April 6, 2020

Mr. William A. Jackson, Chairman  
Berlin Inland Wetlands & Watercourses Commission  
Berlin Town Hall  
240 Kensington Road  
Berlin, Connecticut 06037

Re: ***Wetland Permit Application Review***  
404 Berlin Turnpike  
WMC Project No. 19082

**Figure 3-1 Example Study Limit Determination**

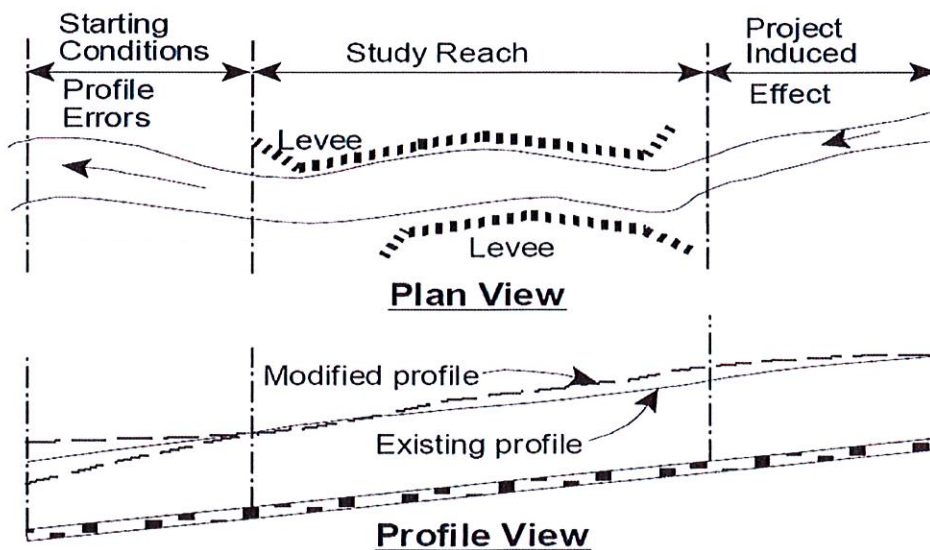
2. The extent of the modeling is inadequate. The hydraulic model starts at Rt 15 on the downstream end and terminates within the mitigation area at the upstream end. Basic modeling practice is for the model to extend beyond the limits of the affected area. Please refer to Exhibit B, attached herewith. Exhibit B is a section of the HEC-RAS reference manual<sup>1</sup>. Referring to Exhibit A, the model for this project should have started at section R or Q, just downstream of the highway, and continued upstream to section T, just upstream of Webster Brook. As these are locations at which published information is available, the boundary conditions are definable. By terminating the model short at both ends, it cannot be definitively proven that the proposed activity has no effect of flood elevations. WMC had previously sent an e-mail, later forwarded by the Town liaison to the Applicant, requesting that the hydraulic model be extended further downstream. In addition, WMC requested that the Existing and Proposed cross sections be overlaid in the consultant's report, for comparison of the conditions. The HEC-RAS program easily allows for this step. The Applicant has not followed these requests. Neither was addressed in the submission by the consultant.

Section 3764

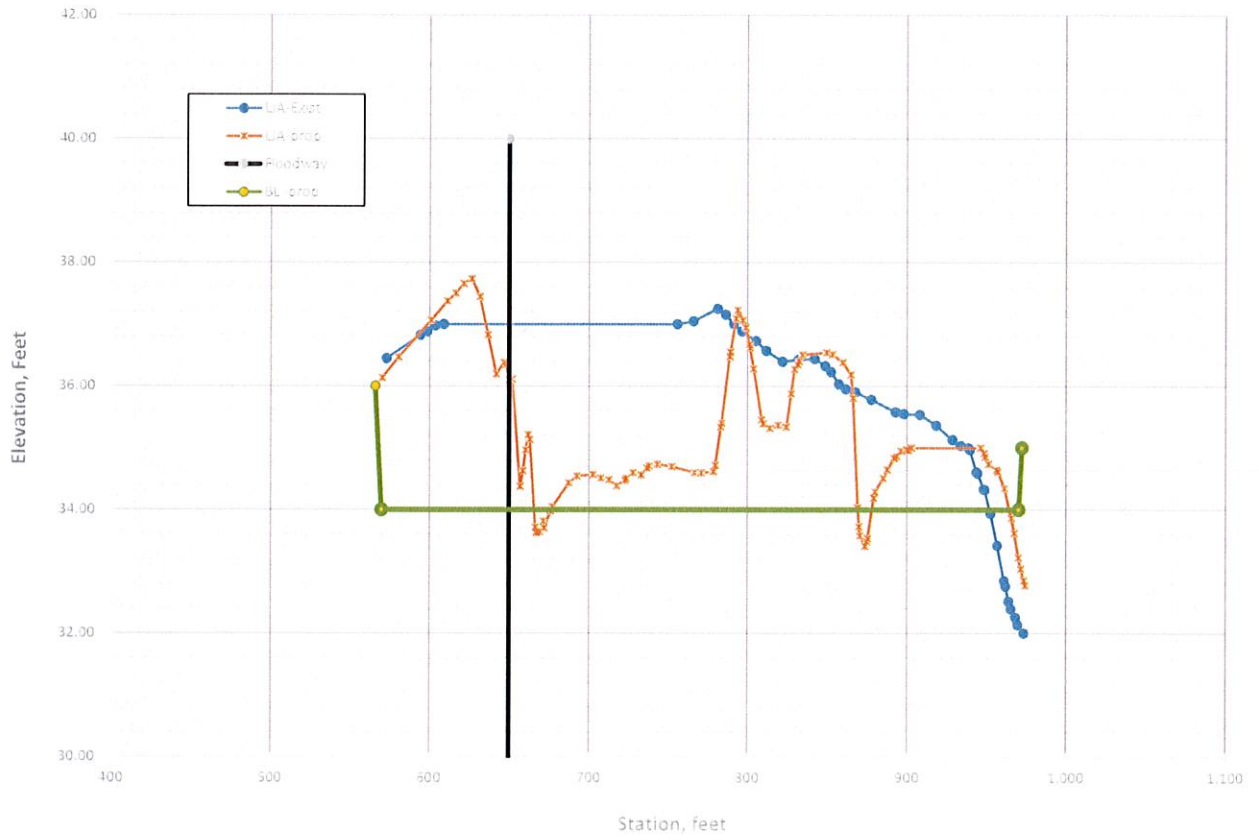
3. The model cross sections are also inaccurate. The cross sections, which show the ground elevation across the identified locations, are to be used to prove that the topography change by addition of the mitigation area does not affect water surface profiles. In order to effectively prove that a change in water surface profiles does not exist, the Existing and Proposed cross sections must reflect the true existing and proposed topography. Please refer to Exhibit C, attached. Exhibit C shows information taken from the consultant's report for Cross Section 3764, which the work map shows to be near the upstream end of the mitigation

area. The data from the output for the existing and proposed condition HEC-RAS models at the segment of this cross section in way of the proposed mitigation area was entered into an excel file. The vertical line on the plot of the data is the Floodway boundary, as included in the HEC-RAS output in the consultant's report. The blue line is data taken from the Existing Condition output, and the orange line is taken from the Proposed Condition output. The bold green line is the actual configuration of the mitigation area taken from the BL Companies plans for the project, as scaled off the work map. Note that Comment 1 above calls into question the accuracy of the mapping. The location and size of the mitigation area varies between the work map and the CAD map from BL Companies. Reviewing the existing topography in the area of the mitigation site, which is shown on BL Companies plan sheet FZ-2, it appears that the Proposed Condition shown in the consultant's study more closely shows the existing condition topography than the Existing Condition from the consultant's study. In addition, it is clear that neither the Existing or Proposed Condition in any way resembles the actual proposed condition at the mitigation site. Also of concern, beyond the area of the mitigation site the Existing and Proposed Conditions for this cross section do not match. As there is no other development proposed around the mitigation site, the Existing and Proposed Condition topography at this cross section – as well as all the other cross sections located in vicinity of the mitigation site – should be identical beyond the bounds of the mitigation area. For all the cross sections near the mitigation site this is not true. Note Exhibit D, which is the first ten (10) data points for Cross Section 3764, located north of the mitigation area. Roughly, these points are located on the Section 3764 line shown on the work map, near the north property line of the project site. For the first ten points, the Existing and Proposed condition profiles are of similar shape, but entirely different stations and elevations. In order to make a comparison of the existing and proposed conditions in the hydraulic models, the cross sections must be exactly the same beyond the area of the proposed work. In this submission, this condition is entirely not met.

From a practical standpoint, the excavation for the propose mitigation area causes a significant increase in the cross-sectional area of the hydraulic cross sections in way of the mitigation area. Once again, refer to Exhibit C for an understanding of the increase in cross-section area due to the proposed mitigation area. The hydraulic section's cross-sectional area, rather than watershed size, has the most impact on the water surface elevations at a particular location. For these hydraulic models, a fixed volume of water (5,800 FT<sup>3</sup>/SEC) is flowing through a cross section that is proposed to gain a significantly area. In addition, the ground elevation of the cross section is lowered by, on average, ±5 feet through the area of the mitigation site. It is highly unlikely that the increased area of the cross sections and lowered ground elevation would not result in changes to the Floodway (encroached) and full floodplain (unencroached) water surface elevations, including the reach of the river at the Town sewerage pump station and the state highway. Furthermore, the Manning's n values (an empirical value representing the "roughness" of the surface over which the water is flowing) is the same in the hydraulic models for the existing and proposed condition at the location of the mitigation site. In the short term (<20 years), the Manning's n value is greatly reduced if the site changes from dense second-growth woods (Existing Condition) to nearly bare (lightly landscaped) and flat (Proposed Condition). A reduced Manning's n value will normally cause an
